# Aldington & Mersham Support Group

## Supplemental Questions and areas of further clarification

### ***Cross-section across the DCO order limits***

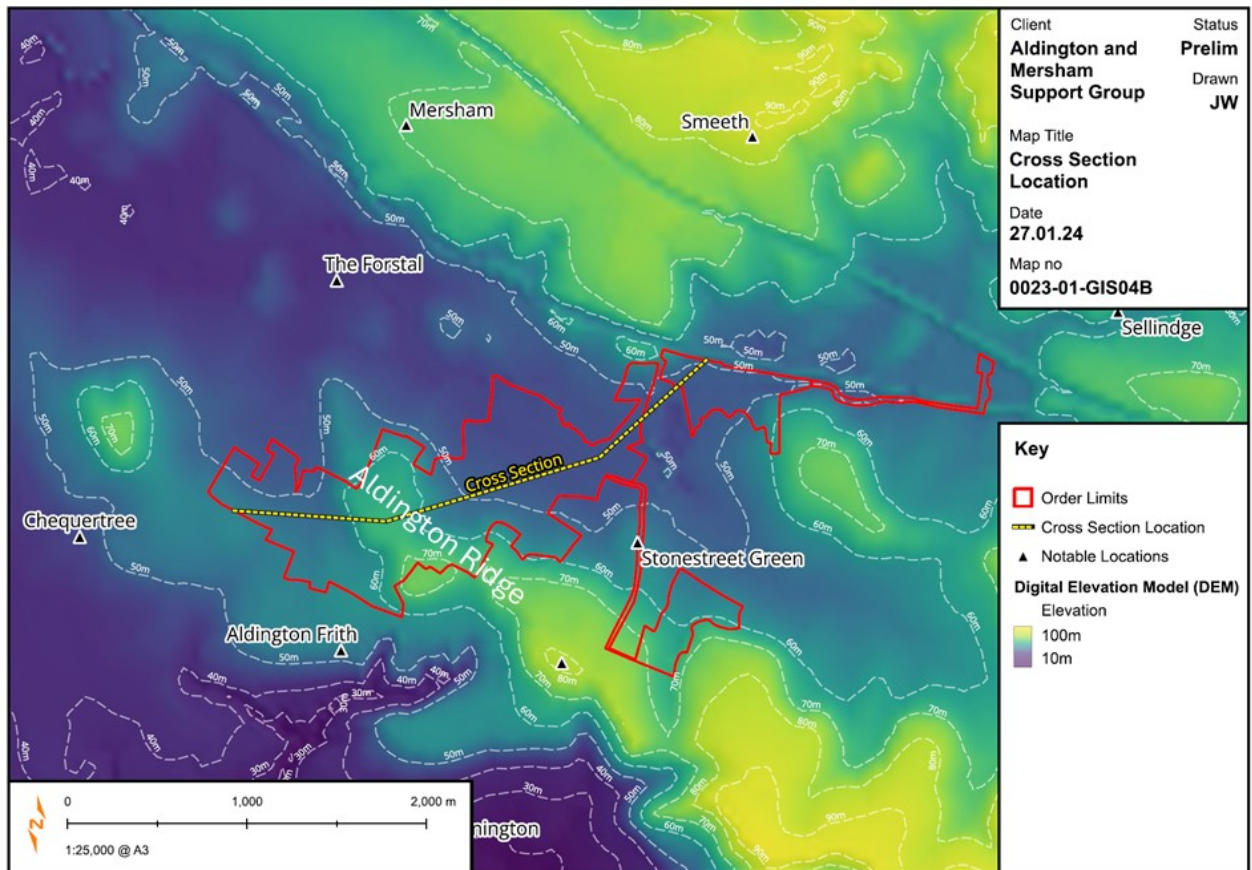
- As identified by the Exa, throughout the consultation process and in the Environmental Statement the Applicant referred to the proposed site as a "bowl", the implication being that a bowl improves the screening of the solar and BESS infrastructure. The below topography map and cross-section show the reality, with the dominant topographic feature within the order limits being the SE-NE trending Aldington Ridge and no evidence of the claimed bowl feature.
- "*Visual amenity and site topography*" are two of the criteria used for selecting the Stonestreet Green site (**Ref APP-067 Appendix 5.2 (1.1.1)**). With this

statement in mind how can the Applicant justify locating solar and BESS infrastructure on the high ground of Aldington Ridge?
